Environmental Requests for Additional Information**Proposed Action (PA)****RAI PA-1**

ER Section 2.2.2.5 states that an approximately 2,134 m [7,000 ft] railroad side track would be built adjacent to the existing railroad access loop for spent nuclear fuel (SNF) deliveries

Figure WR-3-1
Surface Drainages to Baker Spring Area.

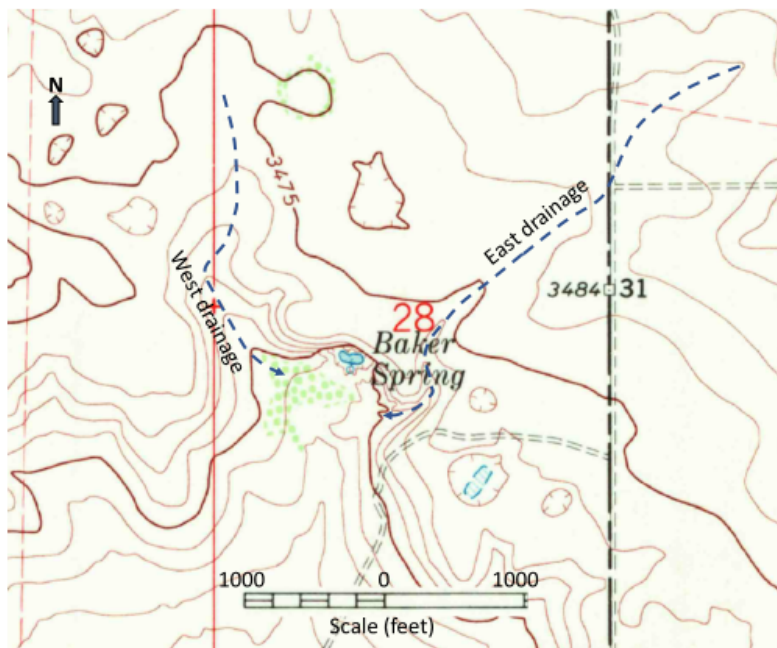
Clarify whether Baker Spring water chemistry data analyzed to date have a chemical fingerprint associated with Gatuña Formation/Pecos Valley Alluvium groundwater, with Antlers Formation groundwater, or with meteoric surface water. Clarify the nature of two groundwater springs located near the proposed CISF:

Baker Spring is not an aquifer-sourced spring, hence the name is somewhat of a misnomer. It is an area where surface runoff is impounded in a shallow excavation into the red bed clays, a remnant of a former quarry at the base of a caprock erosional bench. Two relatively short surface water drainages from the northwest and northeast discharge off the bench to the Baker Spring area. Occasionally ponded surface water may infiltrate into the Gatuna gravels at the base of the former quarry, eventually being released back to the excavation as bank storage seepage or evaporation. Baker Spring is visually inspected monthly by Waste Control Specialists environmental technicians, as are all the playas in the Waste Control Specialists facilities area. Over the past five years, water at Baker Spring has been noted only four times (July 2014; May 2015; January 2016; and January 2017). The pond has been dry during 2018 and 2019.

Although Lehman and Rainwater (2000, page 17 from Reference [4]) state that “water appears to discharge from the Gatuna Formation at Baker Spring,” Dr. Lehman is quoted in the Low-Level Radioactive Waste (LLRW) Application (2007) as stating “I never observed water discharging from the gravels at Baker Spring” and further that it was an assumption that “water may have (or must have?) discharged there at some time (perhaps before the gravel pit was excavated)”.

Figure WR-5-2
Windmills within 5 Miles of the Proposed CISF Identified on USGS
Topographic Maps (1:24,000 & 1:250,000).

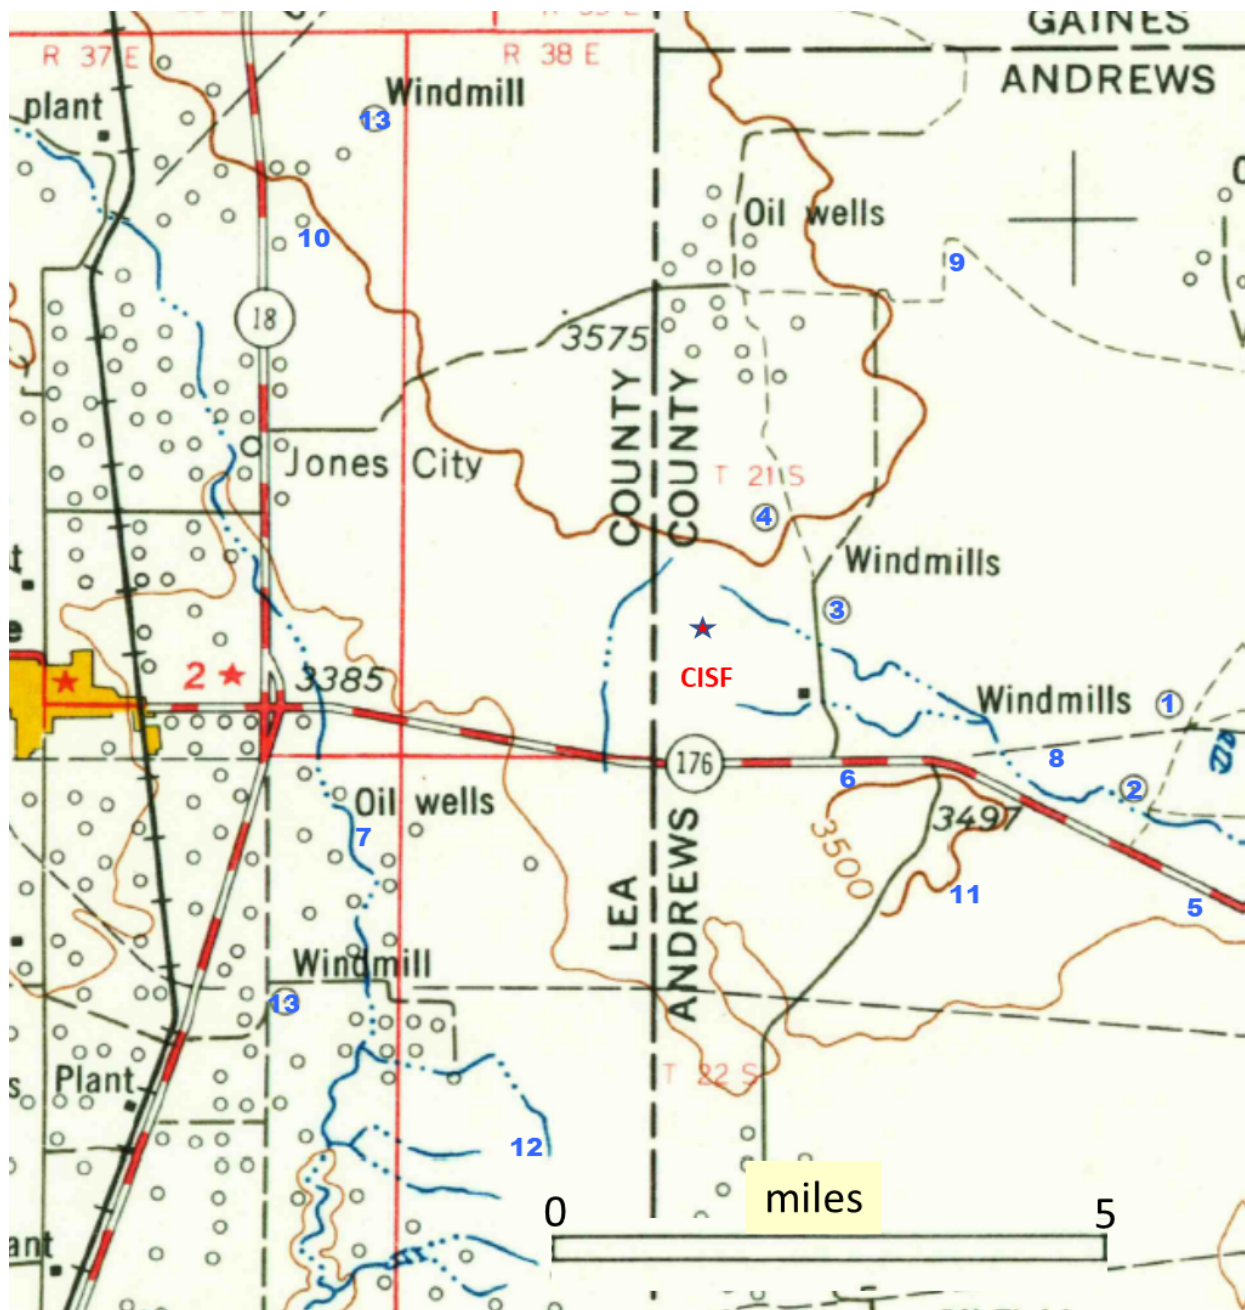
- All active, industrial groundwater wells located on the ISP/WCS property that provide non-potable water for a firewater tank, processing activities, dust suppression, or any other industrial use; show all such ISP/WCS well locations on a map and provide well-perforation depths. Identify the aquifer formation(s) of the non-potable water pumped from these wells (give specific formation names, such as Trujillo or Santa Rosa Formations; “Dockum Aquifer” is not sufficiently specific). Provide, per hydrostratigraphic unit, the annualized volume of non-potable groundwater now in use for ongoing activities at WCS, estimate any anticipated future changes to the annualized volume of non-potable water that will be consumed for non-CISF activities, and estimate the additional annualized volume of non-potable water per aquifer that ISP would use exclusively in activities associated with construction and operation of the CISF during its various phases. Clearly identify which proposed CISF-related activities would require use of site industrial groundwater, and how CISF buildout phase would affect consumptive use.

Windmills identified on United States Geological Survey (USGS) topographic maps are shown in Figure WR-5- 2 (USGS Hobbs, New Mexico, 1:250,000, USGS Jumbo Hill, Texas, 1:24,000; USGS Eunice, NE, Texas-New Mexico; USGS Brinson Ranch, Texas, 1:24,000; USGS Hobbs SE, Texas-New Mexico, 1:24,000). A current water well search conducted by Banks Environmental Data Inc. is included as Attachment WR 5-1, and a previous water well search conducted by Banks and Waste Control Specialists and submitted with the LLRW Application (Reference [6]) is included as Attachment WR 5-2. The water well search submitted with the LLRW application is the more comprehensive and to the extent the Waste Control Specialists well search can be correlated with the USGS-identified windmills, the interpretation is provided below in Table WR-5-1. It is assumed that shallow wells (less than 200 ft depth) are open to either the Ogallala, Antlers or Gatuña (also likely termed Cenozoic Pecos Alluvium in some areas) Formations. Deeper wells are likely open to sandstones in the Triassic Dockum Group. It may be speculated that shallow wells located in the Colorado River surface water drainage basin are potentially open to the Ogallala Formation, or possibly the Antlers/Ogallala undifferentiated, and that shallow wells located in the Rio Grande drainage basin are open to the Gatuña (Pecos Valley alluvium) Formation, or possibly the Antlers/Gatuna undifferentiated. The buried red bed ridge separates the groundwater systems of the Ogallala and Gatuña (Pecos Valley alluvium) Formations, however as discussed in RAI-WR-4, the drainage divide between the Colorado and Rio Grande basins is approximately coincident with the red bed ridge; however, they are not co-located, therefore, there is some uncertainty near the approximately coincident divides as to the groundwater system in which wells may be.

Figure WR-7-2
Top of Antlers/Ogallala

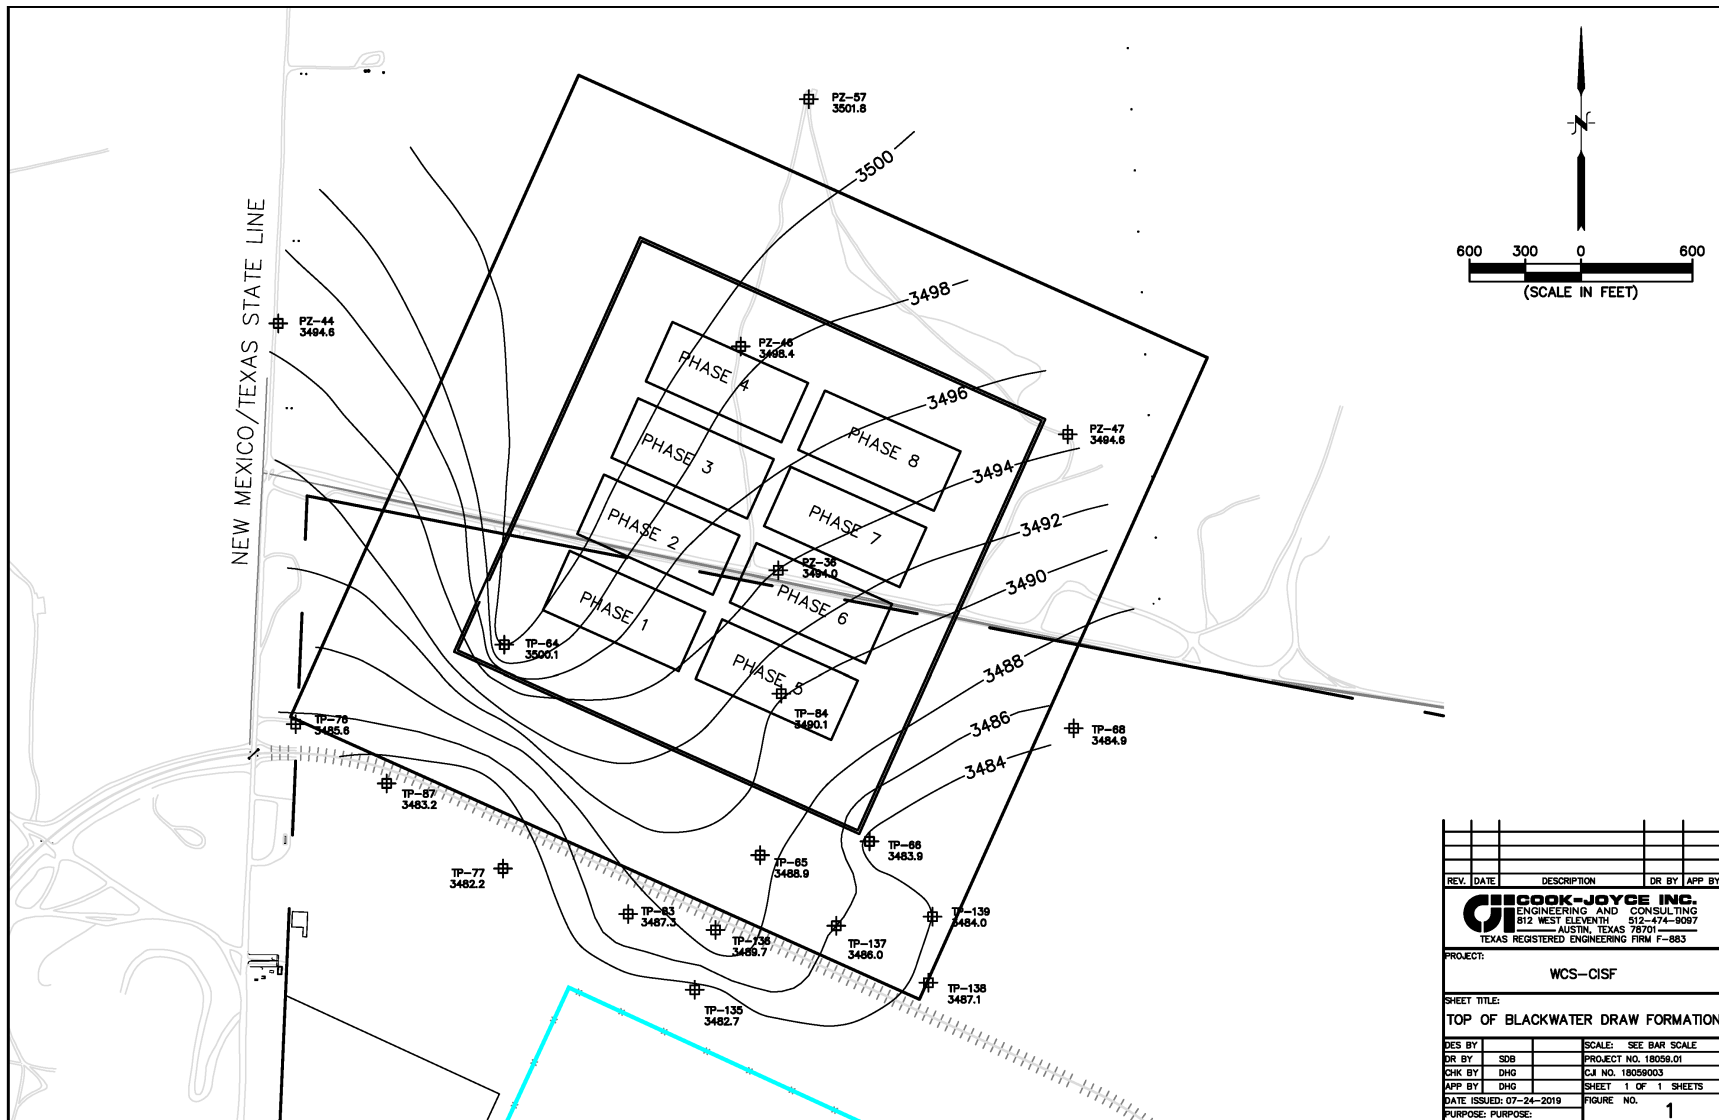
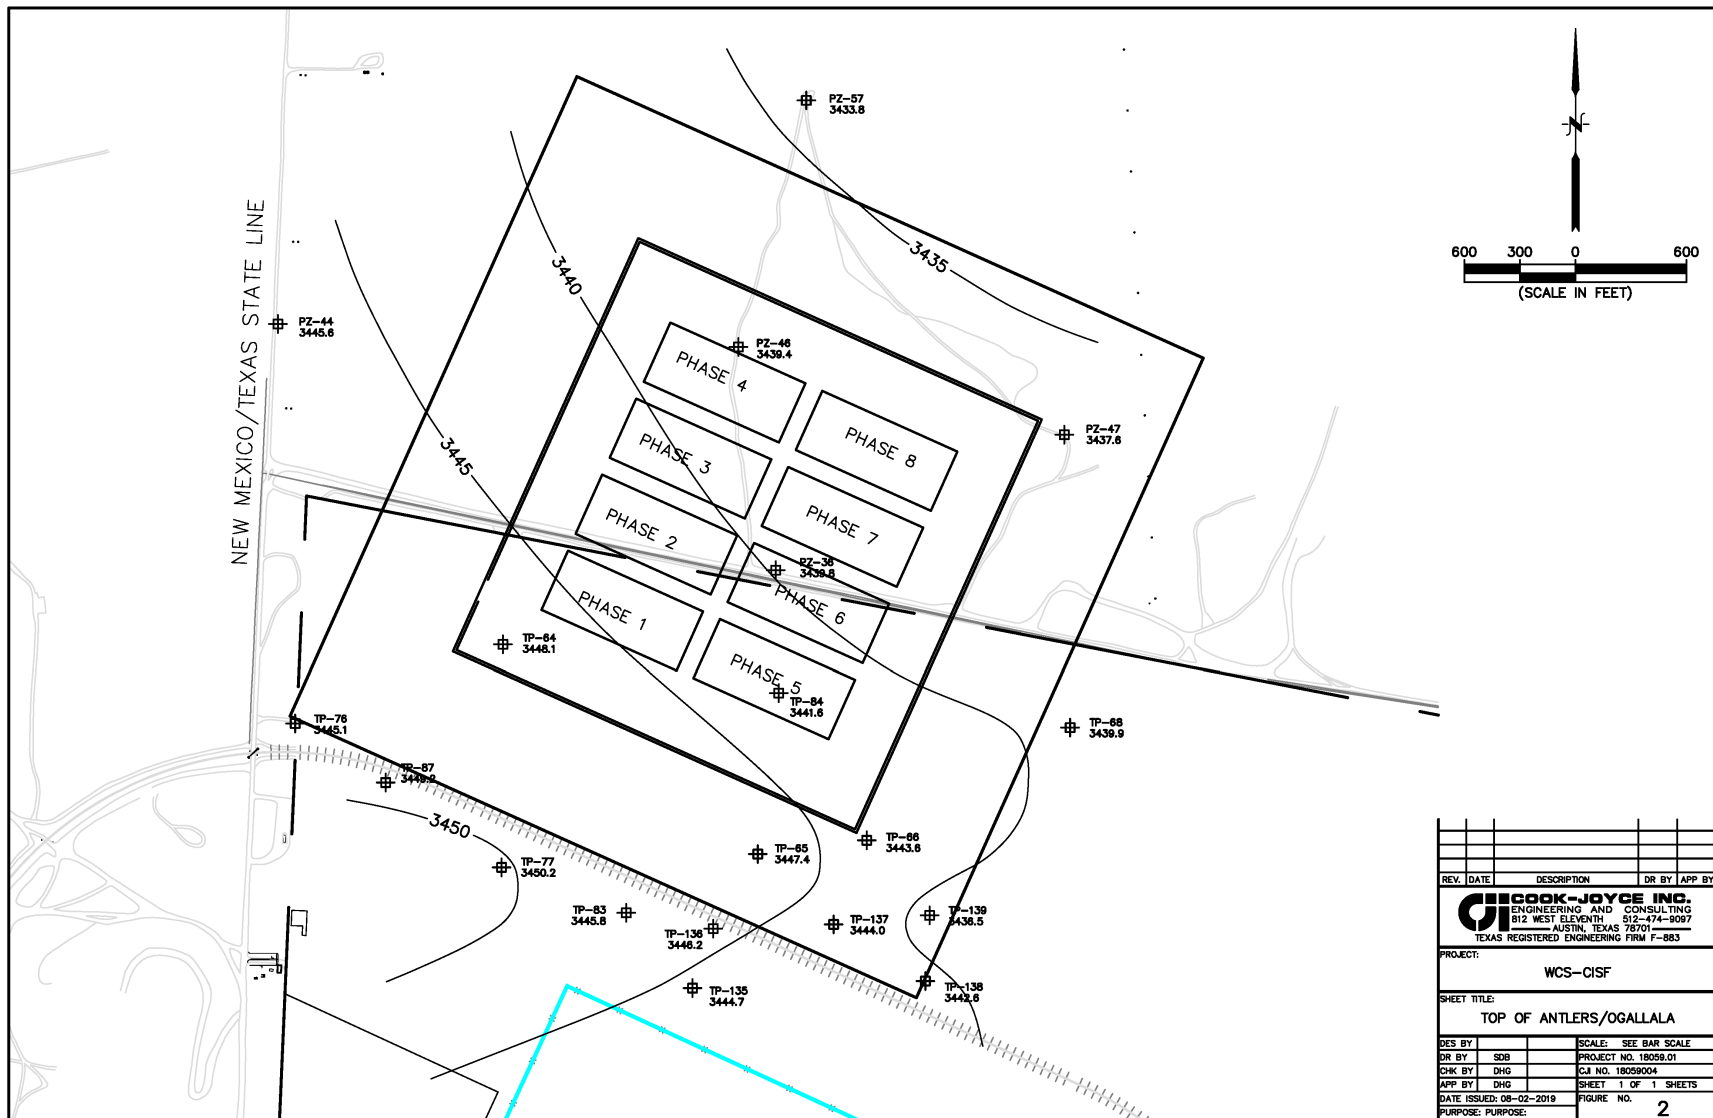
Provide isopach maps for the tops of hydrogeologic units beneath the proposed CISF site, including isopach maps for the tops of all formally named formations and for the tops of water-bearing sand lenses occurring within the Cooper Canyon Formation.

Reference [1] includes information for numerous borings and piezometers in the proposed CISF area, with the primary objective of identifying the top of the Triassic Cooper Canyon mudstones. Based on these borings, structure maps for the tops of the Blackwater Draw and Antlers/Ogallala (undifferentiated) Formations are provided in Figures WR-7-1 and WR-7-2. The Quaternary Blackwater Draw (Figure WR-7-1) is situated immediately beneath the Recent cover sands, which are relatively thin in the proposed CISF area, generally less than about 2 ft. The Blackwater Draw silty sands have various stages of caliche development, whereas the cover sands are relatively loose with no discernable caliche. The top of the Blackwater Draw structure map in Figure WR-7-1 is based on the first occurrence of caliche in the Waste Control Specialists boring logs. The eighteen SAR Phase I/Admin/Transfer area geotechnical investigation boring logs (WCS CISF SAR Attachment E) in the southwest corner of the proposed CISF area are reasonably similar to the Waste Control Specialists logs (WCS CISF SAR Attachment C), showing loose- to medium-dense silty sand in the upper 2.5 to 6 ft, with caliche mentioned, but the contact between the loose cover sands and the first silty sand with caliche is not specifically identified. Therefore, the Geotechnical Borings in Attachment E of the WCS CISF SAR are not explicitly included in Figure WR-7-1. Their inclusion would result in only a few feet variation of the top of the Blackwater Draw.
